1A & 1B VALLEY ROAD
59 - 63 TRAFALGAR AVENUE
LINDFIELD

SSD APPLICATION - DESIGN REPORT

APPENDIX AP6. RTS RFI RESPONSE

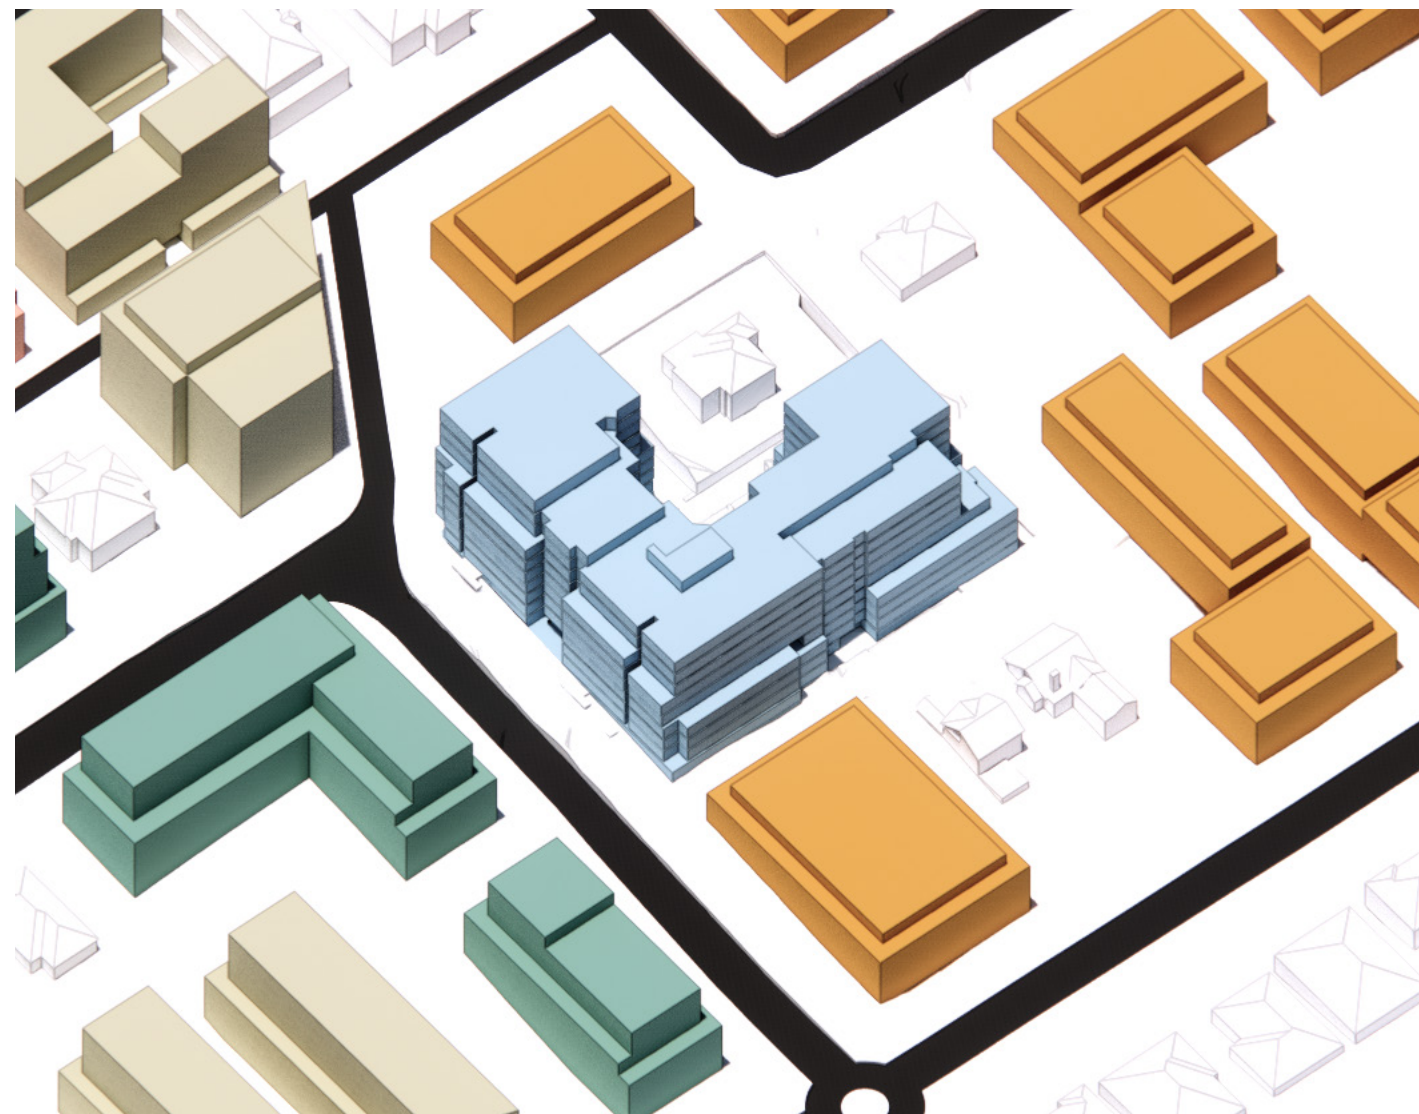
7. Consistent with the advice provided by the SDRP, consider and test options to reduce the perceived bulk and scale of the buildings from the public domain and neighbouring properties.

- a. breaking down the form and mass of the development to avoid a large single consolidated form
- b. increased street, side and rear landscaped setbacks (see points 8 -11 below)
- c. further articulation of building facades to assist in providing a transition to the surrounding low scale heritage residences.
- d. visually breaking the development into smaller architectural facades, buildings or elements and other facade treatments, as recommended in the heritage impact statement (HIS).

7a. Breaking the building into smaller consolidated volumes would reduce the achievable gross floor area and floor space ratio, resulting in an outcome that does not optimise the sites capacity to deliver much needed housing. This would be inconsistent with the strategic planning objectives for the area and Ku-ring-gai Councils obligations to facilitate housing supply and diversity within well-located centres. Refer to Desired future charater on page 63.

The proposed building form represents an efficient use of the site while remaining compliant with the applicable planning controls. Rather than fragmanting the envelop, the design employs architectural articulation, facade modulation, material variation and upper level setbacks to reduce preceived bulk and scale from the public domain and neighbouring properties achievin visual relief and an appropriate human scale without compromising housing yeild.

SETBACKS - TYPICAL PODIUM

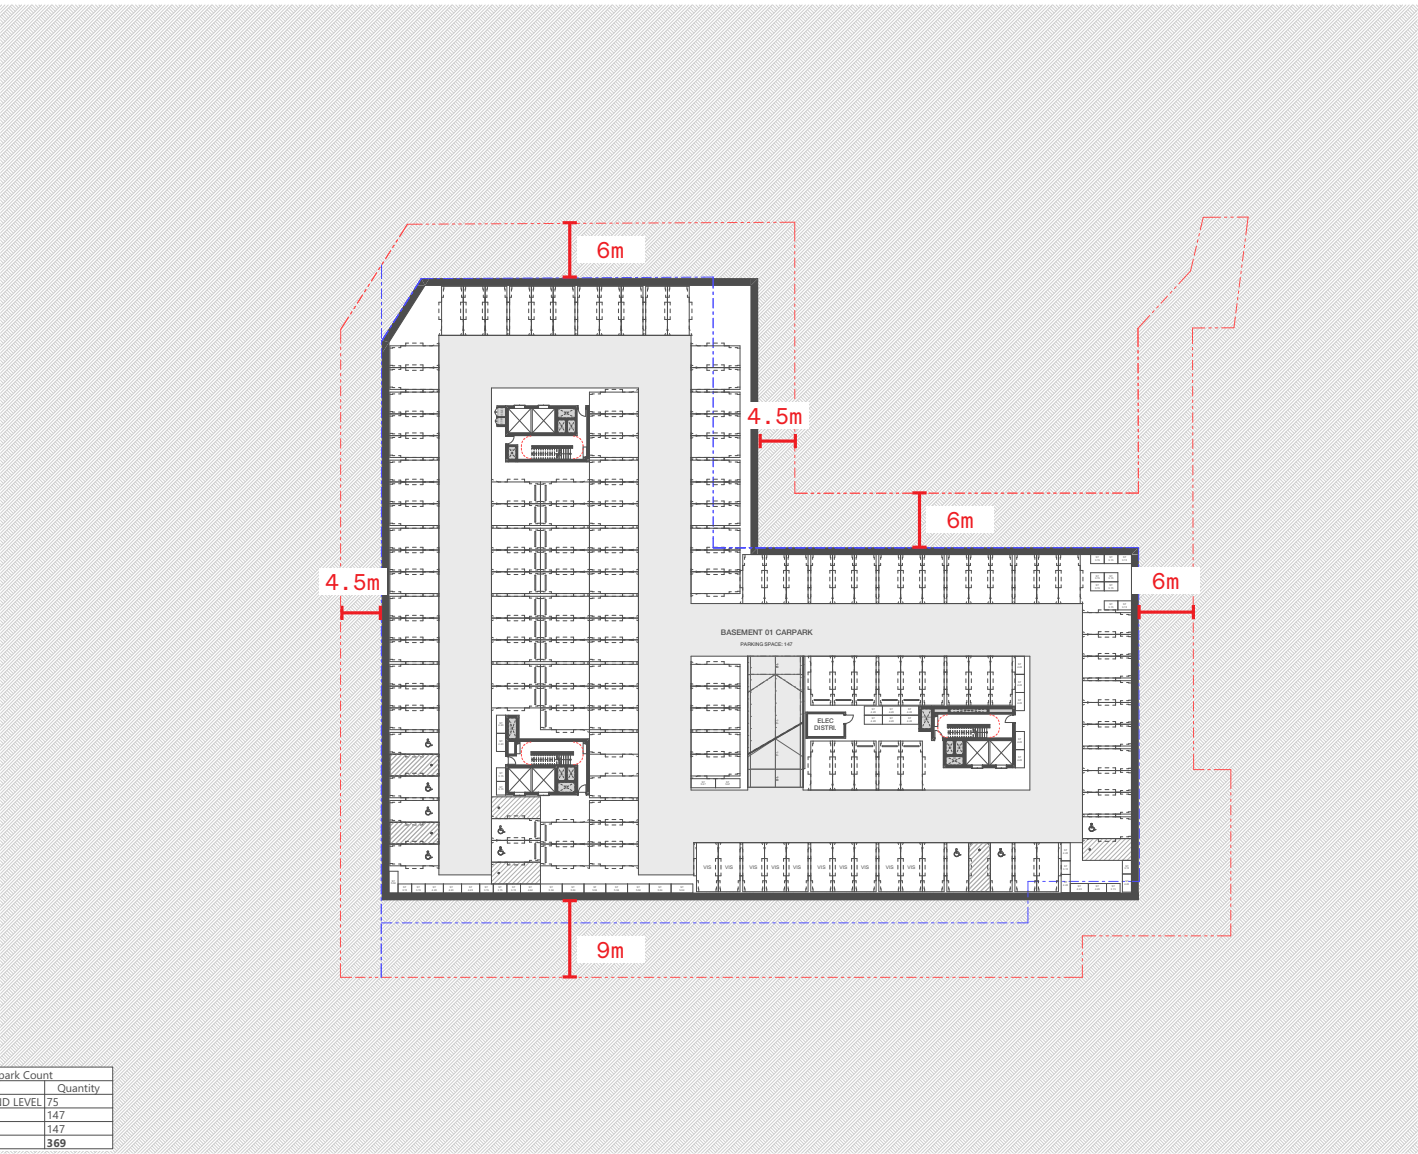
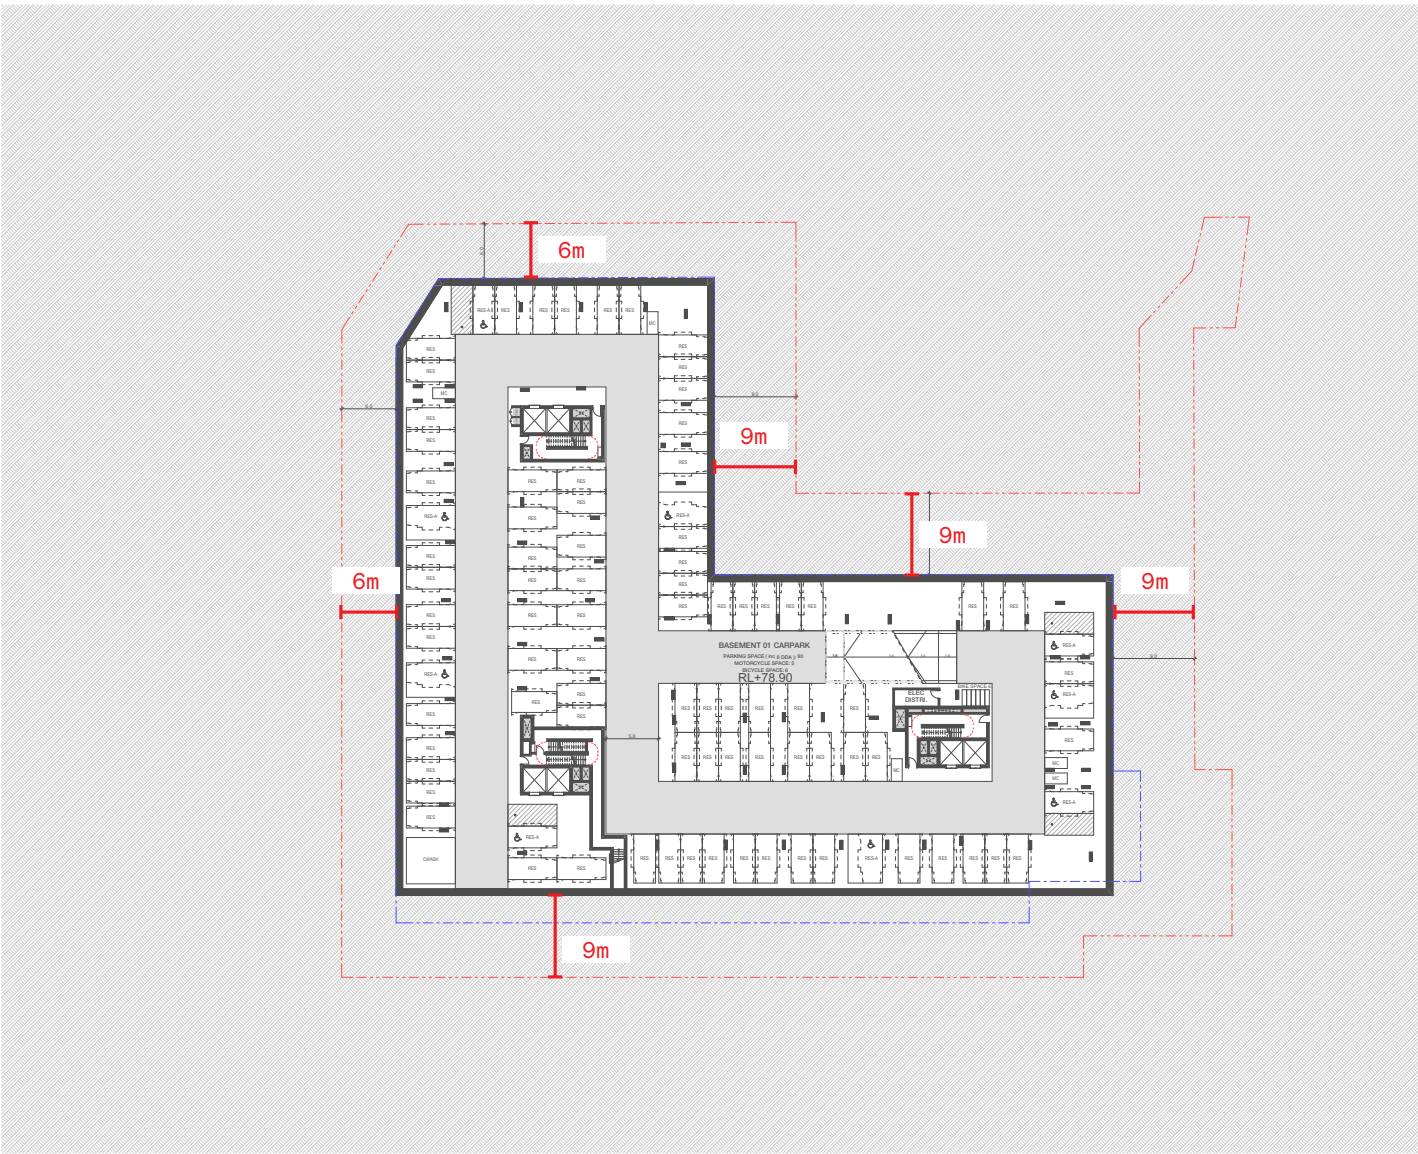
8. The minimal street setback to Trafalgar Avenue is insufficient to mitigate the visual impacts of the development and is inconsistent with the landscaped ‘garden’ character of Lindfield. The street setback should be increased to be more sympathetic to the surrounding context and provide a greater landscaped buffer to contribute to the character of the area.

10. In conjunction with exploring alternative built form options in point 7, consider options to further increase building setbacks to heritage items in line with the Apartment Design Guide (ADG) recommendation that setbacks should be increased where a residential flat building adjoins low density zoned development. Updated plans and details, including building separation diagrams with dimensions, are required to demonstrate that the proposal provides:

- c. dense landscaping within setbacks to protect the setting and views from heritage items.
11. The extent of basement should be reduced so it does not encroach into the front, side or rear setbacks. This would allow more deep soil planting to contribute to the landscaped character of the area and mitigate the visual impacts of the development from the public domain and neighbouring properties.

The updated scheme incorporates an increased street setback of 6m - 9m. This allows ground-level units facing Trafalgar Avenue to accommodate private courtyards, aligning with the ‘garden’ character of Lindfield. The wider setback also enables the planting of mature, denser landscaping, providing enhanced privacy and acting as a buffer to reduce noise.

At the top level, additional setbacks have been introduced along the southern edge to provide a more generous transition and reduce visual impacts on neighbouring properties. Planters along the perimeter of the rooftop communal open space further soften the building’s upper edge, creating a greener, more visually cohesive frame that complements the surrounding landscape character.

The basement extent has been reduced to remain fully within the building envelope, avoiding encroachment into the front, side, and rear setbacks. This adjustment increases deep soil areas, contributing to Lindfield’s landscaped character while significantly reducing visual impacts from both the public domain and neighbouring properties.

Despite the increased building setbacks, all private open spaces continue to comply with the ADG minimum 6-metre building separation requirements. Privacy is further reinforced through the provision of boundary fencing and dense landscaping within deep soil zones, ensuring effective screening and separation from adjoining properties.

VALLEY RD INTERFACE

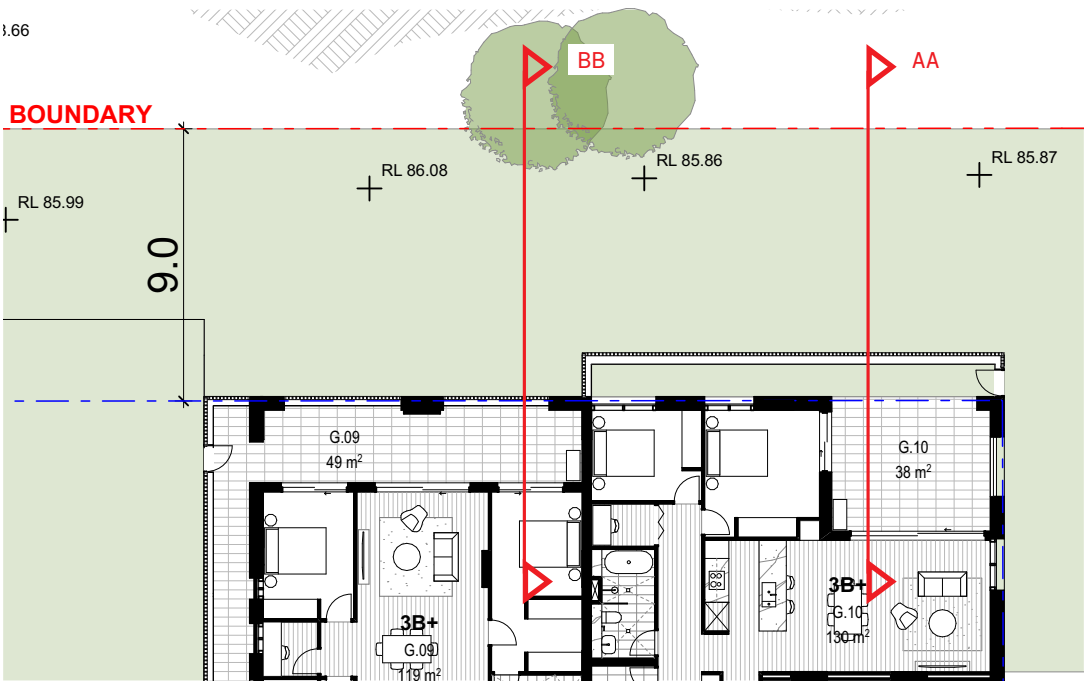
10. a. Review the setbacks on Upper Ground floor to Middle Harbour Road and Ground Floor for 1 Valley Road.

SECTION BB

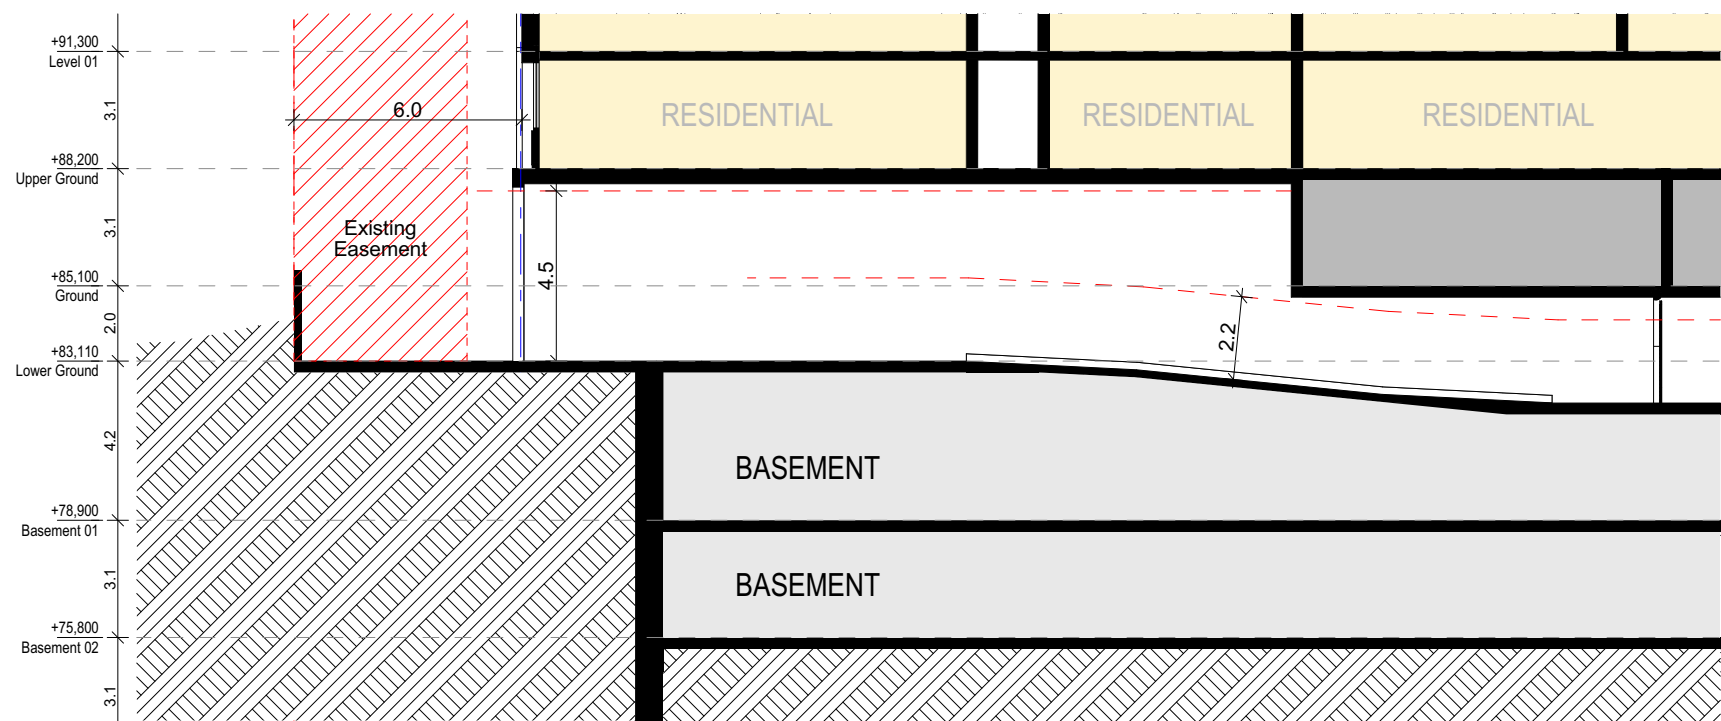
13. Provide an updated transport impact assessment with the following:
- a. details of the pedestrian and vehicular access arrangements (including swept path analysis of the largest vehicle and height clearances)

Section Provided demonstrated height clearances shown on Drawing DA312.
